IEEE P802.15 Wireless Personal Area Networks

Project	IEEE P802.15 Working Group for Wireless Personal Area Networks (WPANs)	
Title	TG3 LB19 comment resolution	
Date Submitted	[24 September, 2002]	
Source	[James P. K. Gilb] [Apparent Technologies] [9921 Carmel Mountain Rd. #247, San Diego, CA 92129]	Voice: [858-538-3903] Fax: [858-538-3903] E-mail: [gilb@ieee.org]
Re:	[]	
Abstract	[This document is a record of comment resolutions for LB19.]	
Purpose	[To provide a record of the comment resolution for LB19.]	
Notice	This document has been prepared to assist the IEEE P802.15. It is offered as a basis for discussion and is not binding on the contributing individual(s) or organization(s). The material in this document is subject to change in form and content after further study. The contributor(s) reserve(s) the right to add, amend or withdraw material contained herein.	
Release	The contributor acknowledges and accepts that this contribution becomes the property of IEEE and may be made publicly available by P802.15.

Figure 4—PNC handover MSC

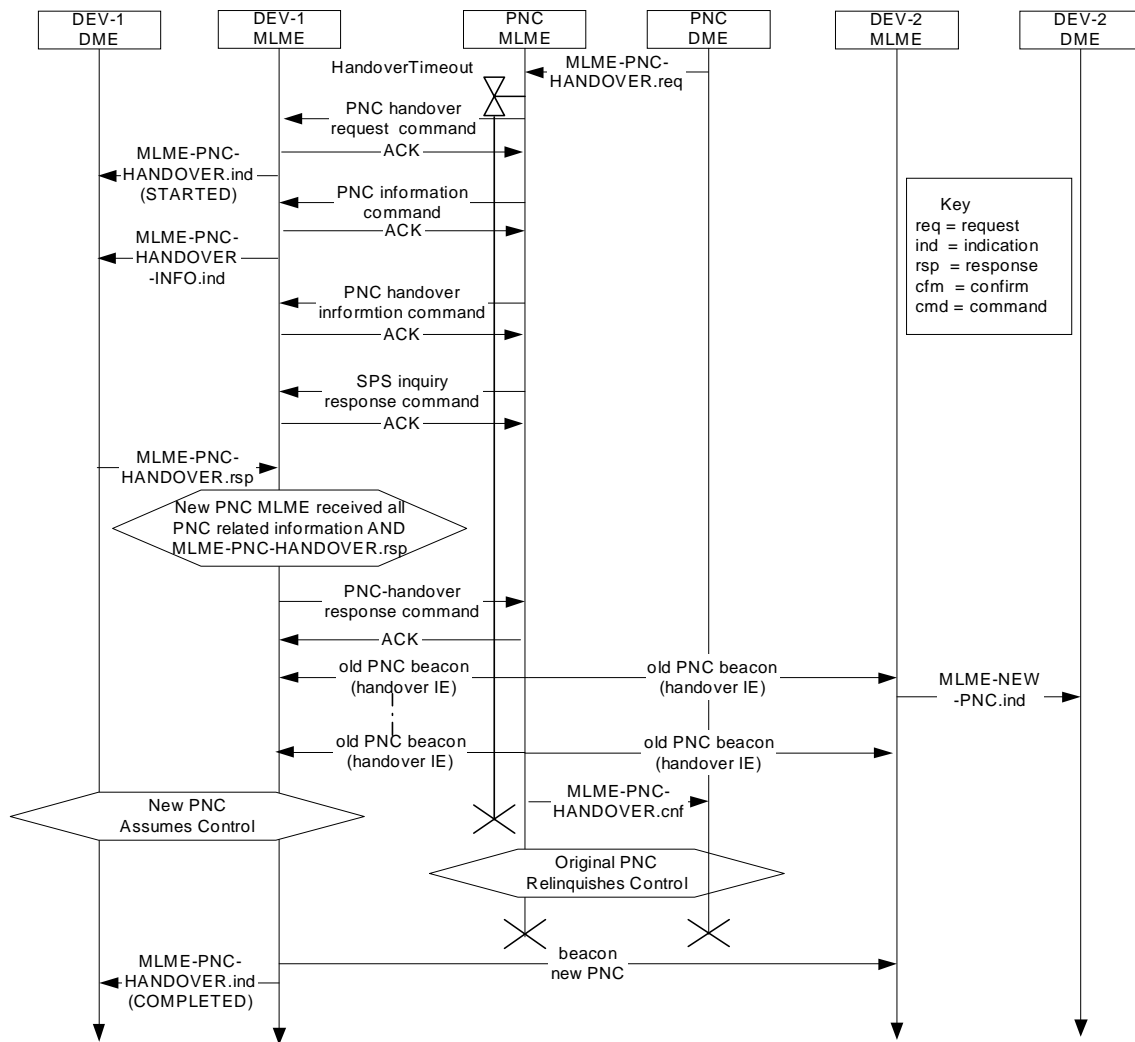
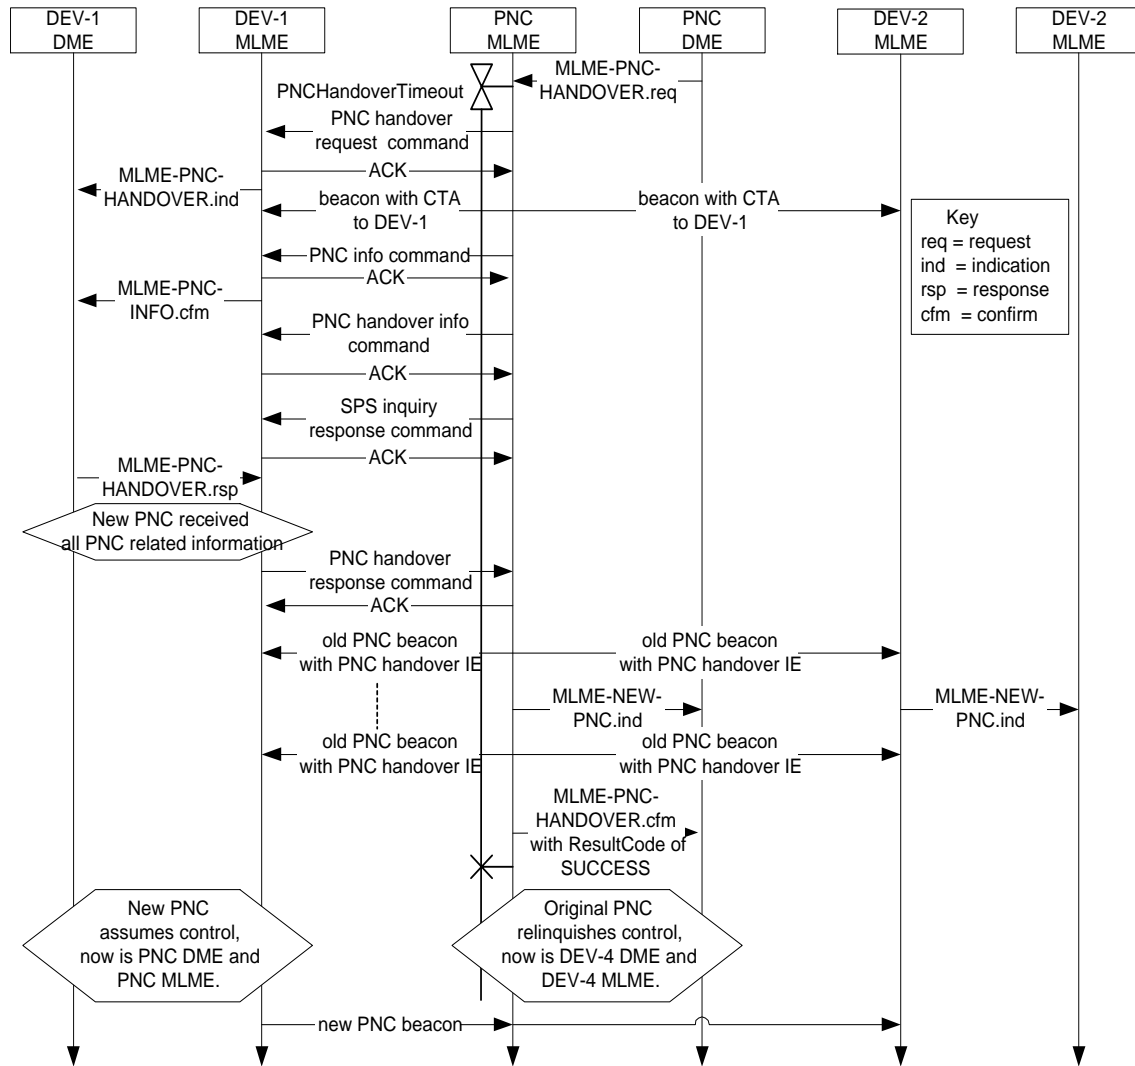
269 (Heberling, TR) - [PNCHndOvr] Some errors in text remain or were introduced after LB17.MSC in Figure 91 is also wrong. KO Text changes for 8.2.3 and ne MSC for Figure 91 are all collected in: 02276r7P802-15_TG3-commentsD11_KO.doc, Resolution [03]. **Suggest accept in principle**, “The MSC will be modified as indicated in the resolutions of CID 58 and 232. Make the following text changes: In 6.3.13.4, page 59, line 45, change ‘This primitive informs the originating DME its request for information from the PNC is complete.’ to be ‘This primitive informs the DME that the MLME has received a PNC information command, {xref 7.5.4.2}.’ In 7.5.3.1, page 138, line 20 ‘the number of information records to be transferred using the PNC information command frame(s).’ to be ‘the number of DEV information records, {xref PNC handover info command}, that will be transferred from the old PNC to the new PNC.’ In 8.2.3 PNC Handover, delete page 156, line 8-9, redundant, same text in paragraph below. Add to page 156, line 19, ‘The PNC handover information command shall not be sent if the PNC has indicated in the PNC handover request command that it does not have any CTRBs to transfer.

Handover MSC - various comments, suggestion from 02276r7P802-15_TG3-commentsD11_KO.doc below (with some editorial work):

Add to page 156, line 35, ‘The new PNC shall broadcast its first beacon at the time the beacon would have been sent by the old PNC. This time may vary from the actual time due to clock inaccuracies of old and new

PNCs. The new PNC shall start sending beacons with the beacon number counter set to one more than the beacon number of the last beacon that will be sent by the old PNC.’

Add page 156, line 40ff, ‘The PNC shall ensure that the beacon countdown includes at least one system wake beacon and at least aMaxLostBeacons beacons following that system wake beacon. The only exception to this requirement is if the PNC will be shutting down and does not have enough time to to wait for the next system wake beacon to complete the handover process. {Ed. note: This line may be moved to a new 8.1.1 that describes all beacon announcements.’ }
